Docket No. 52-001

SUBJECT: FINAL REPORT TO DOCUMENT THE DISPOSITION OF THE IIRG COMMENTS
ON THE GE NUCLEAR ENERGY (GE) ADVANCED BOILING WATER REACTOR
(ABWR) INSPECTIONS, TESTS, ANALYSES, AND ACCEPTANCE CRITERIA
(ITAAC)

INDEPENDENT REVIEW GROUP COMMENTS REQUIRING DISPOSITION BY GE

Figure 2.6.1 Reactor Water Cleanup System

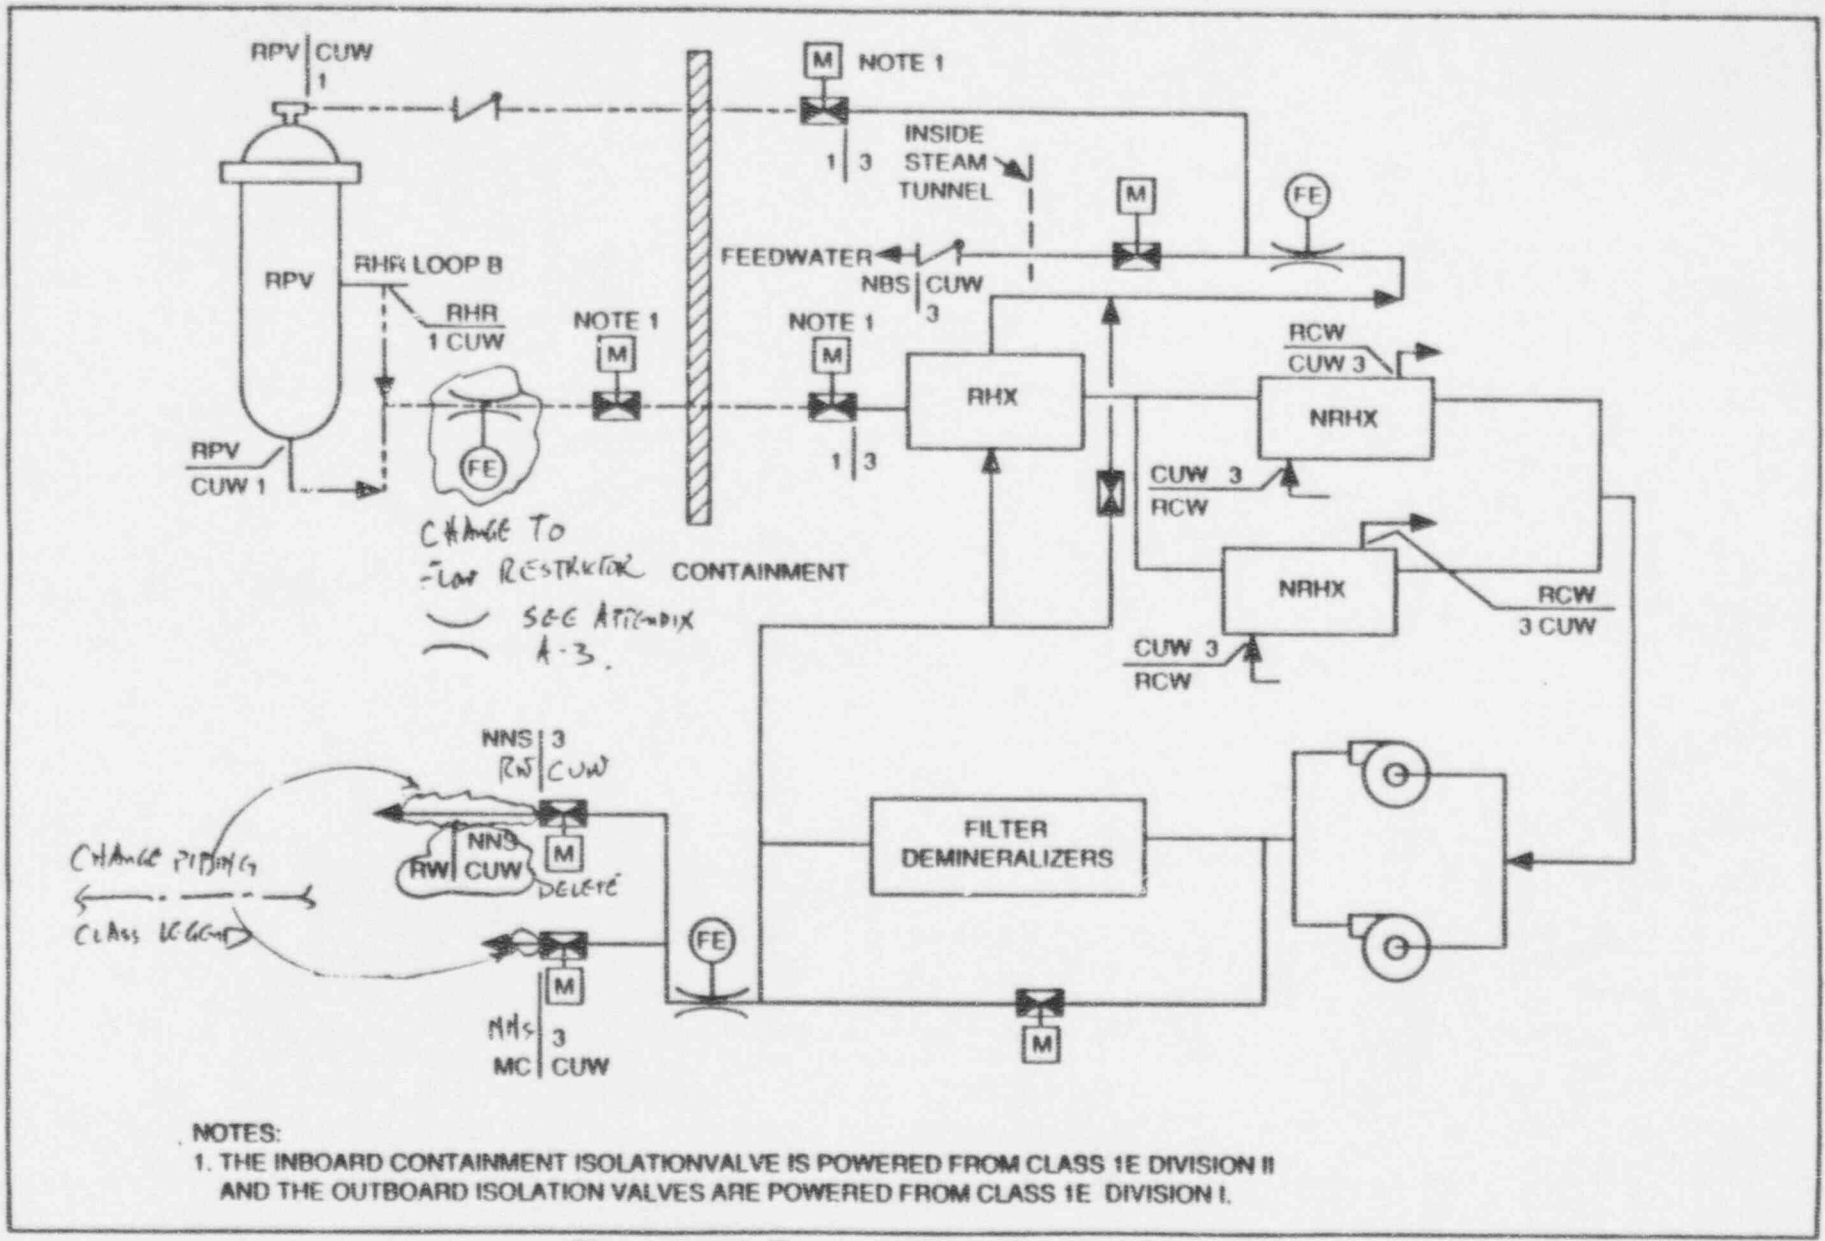
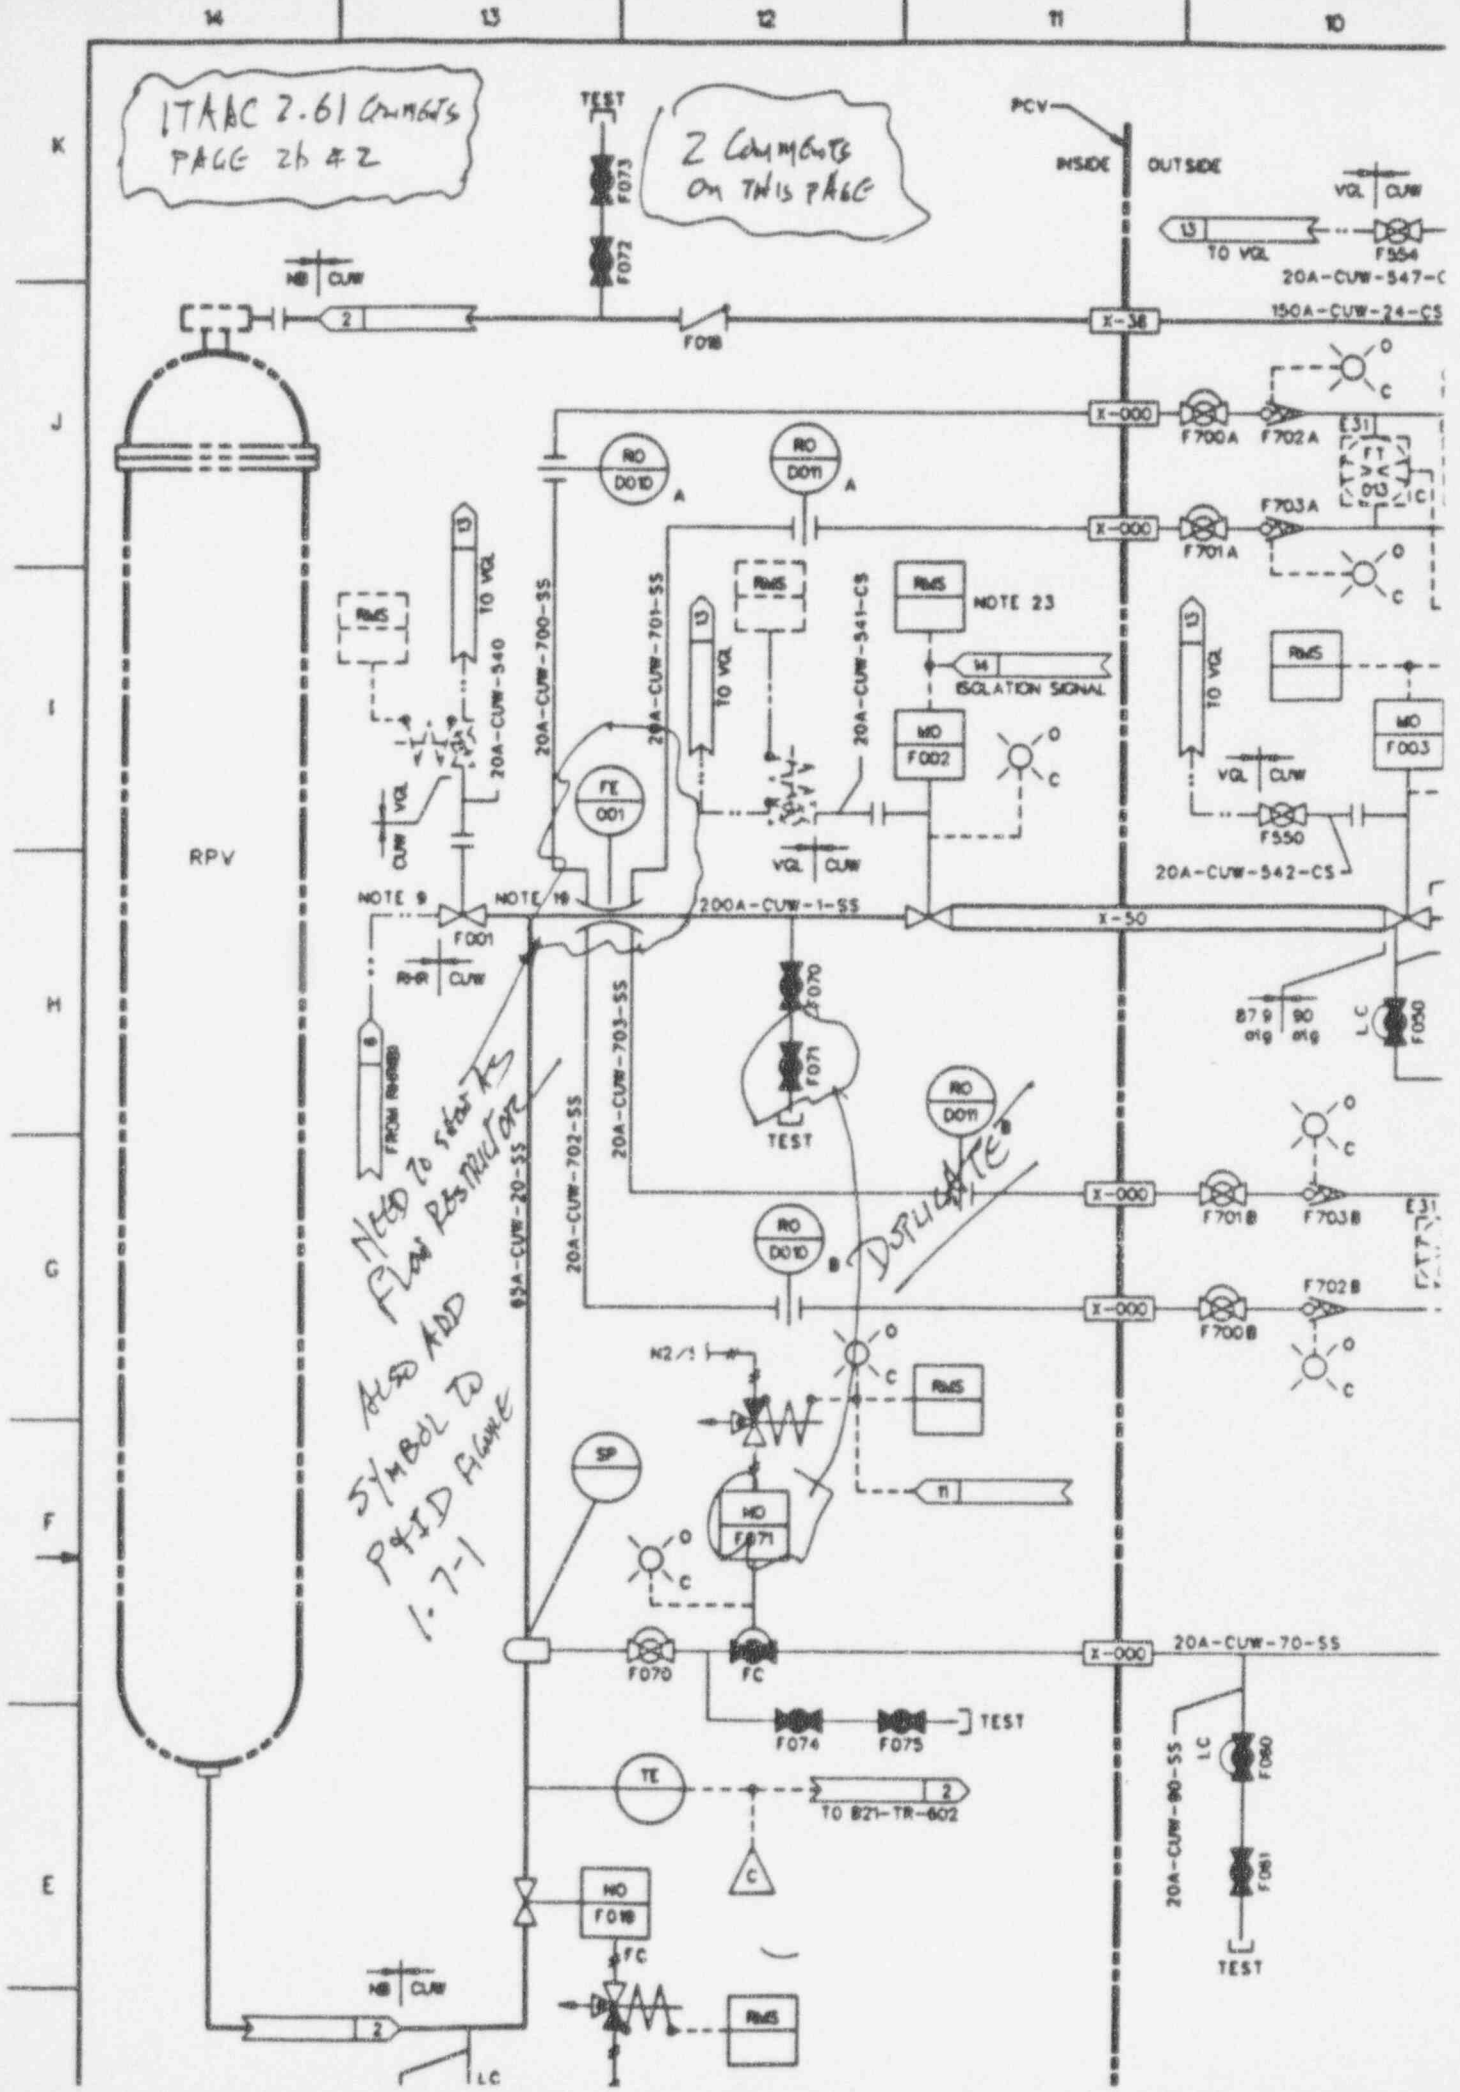
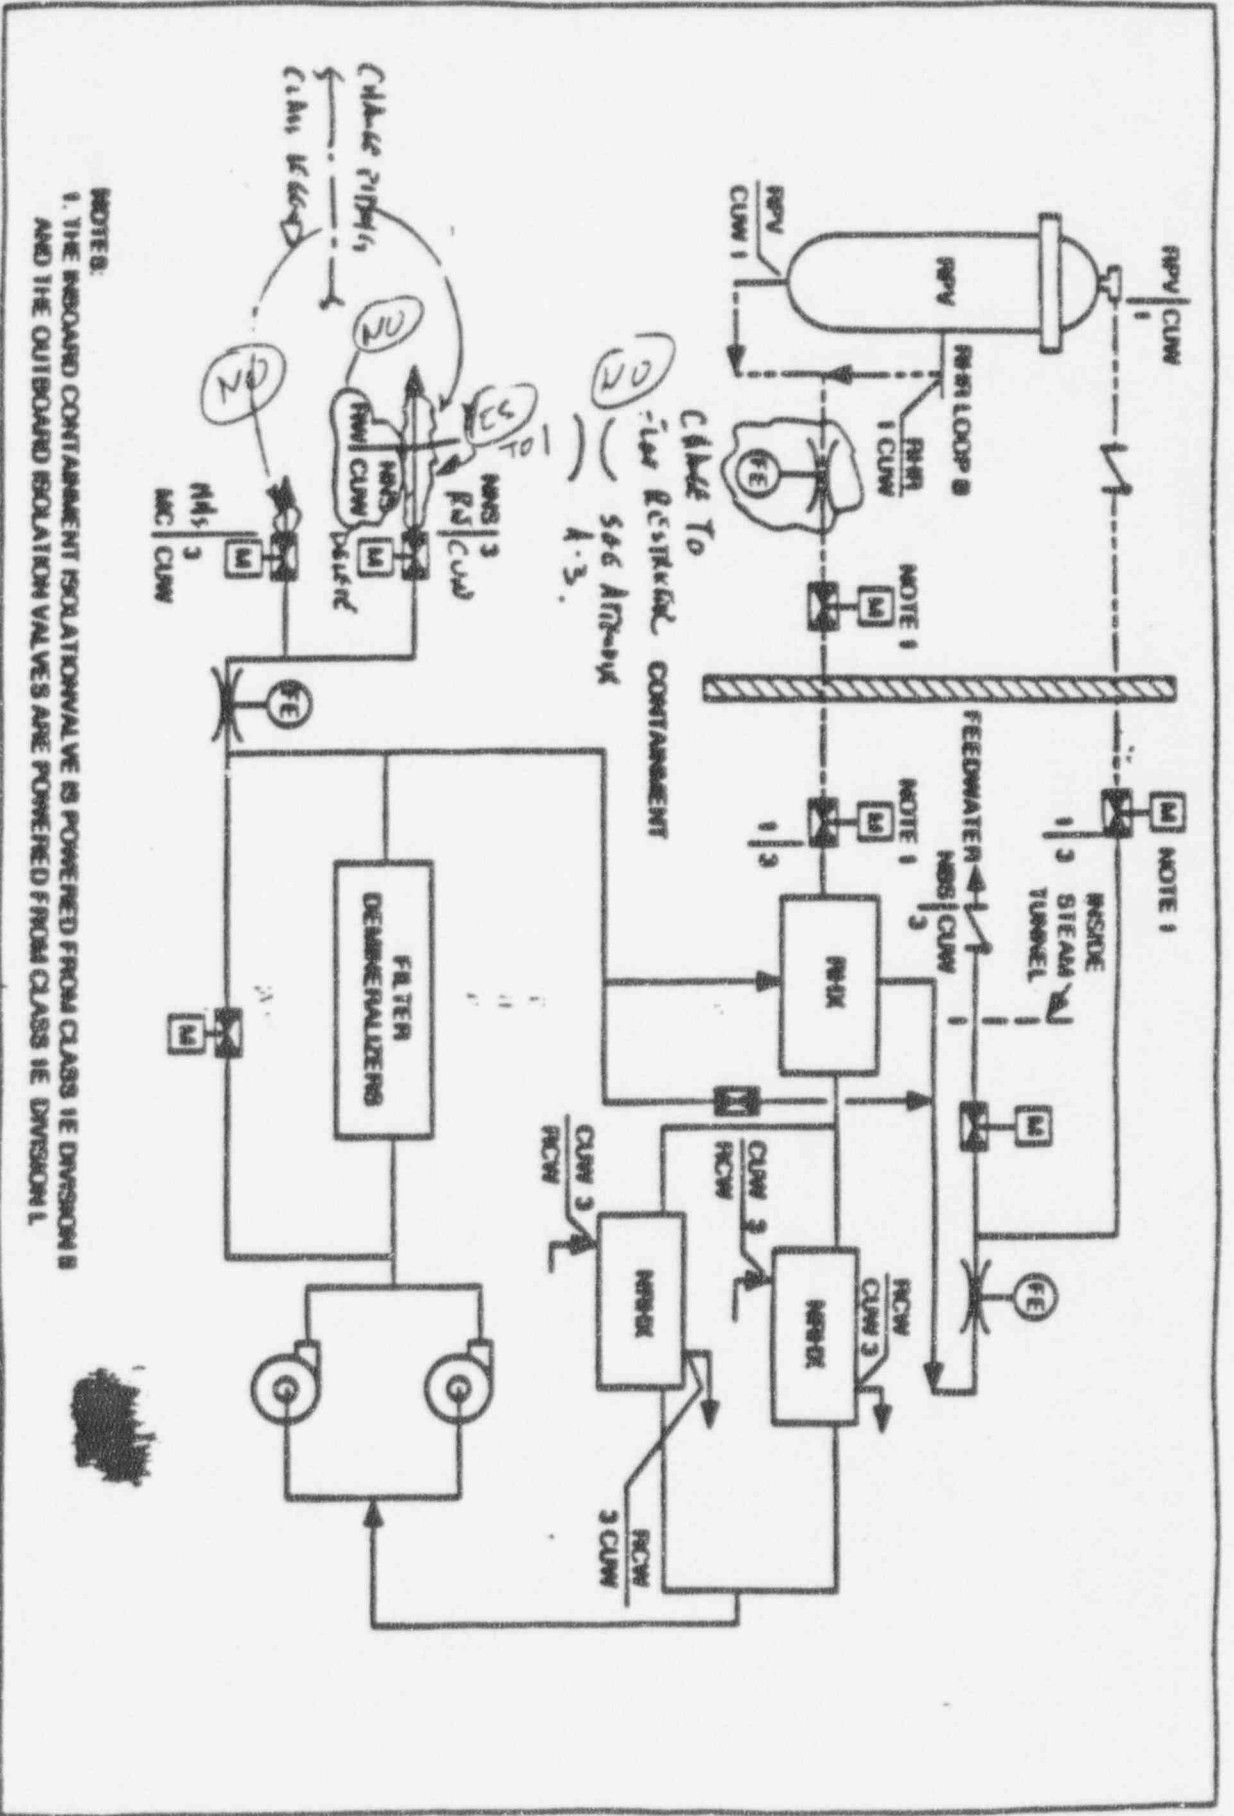
ADD ACRONYM MC
TO APPENDIX B.

FROM REVERSED
NEED TO SHOW THIS
FLOW RESTRICTOR
ALSO ADD
SYMBOL TO
PID ALONE
1-7-1

Need to start
Flow Restriction
AND ADD
SYMBOL TO
P&ID ABOVE
1-7-1

- a) Leave the FE Venturi as-is. This is common use throughout the BWR and represents a dual-function flow measuring device based on a Venturi and a flow restriction device. *f SYMBOL IDENTIFIED IN LEGEND FOR CDM AS A FLOW RESTRICTION ALSO STATED IN DD. SSAR SYMBOL FOR VENTURI ALSO REPRESENTS FLOW RESTRICT.*
- (Continued on next page...)
